## Acom 600S MARS Modification

This mod enables continuous frequency coverage of the Acom model 600S from 1 to 30 MHz.

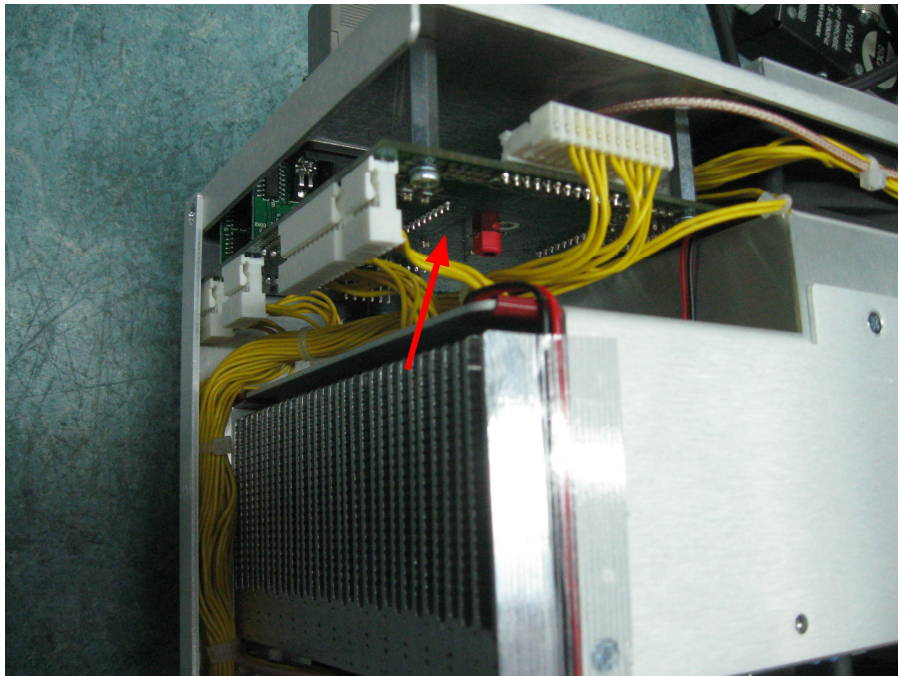
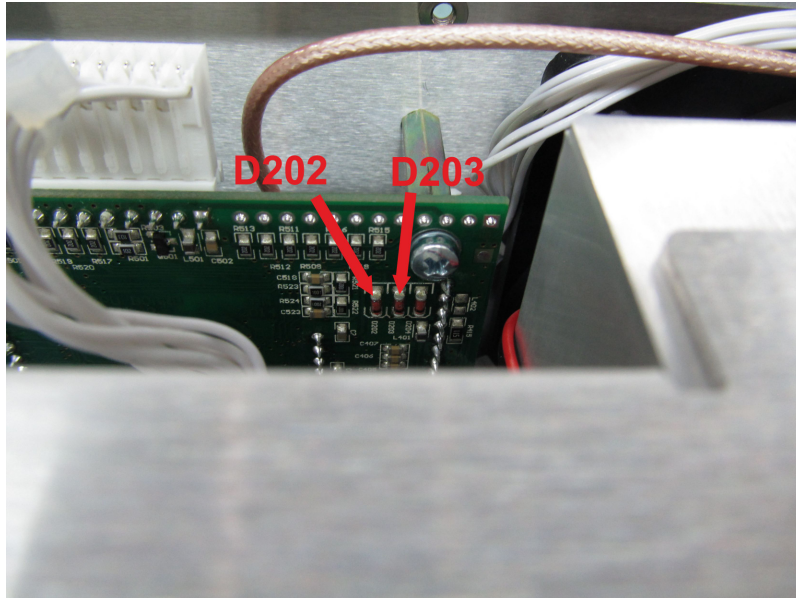
Two diodes need to be removed. D202 and D203.

They are on the bottom of the 600S CPU board as shown in the photos above.
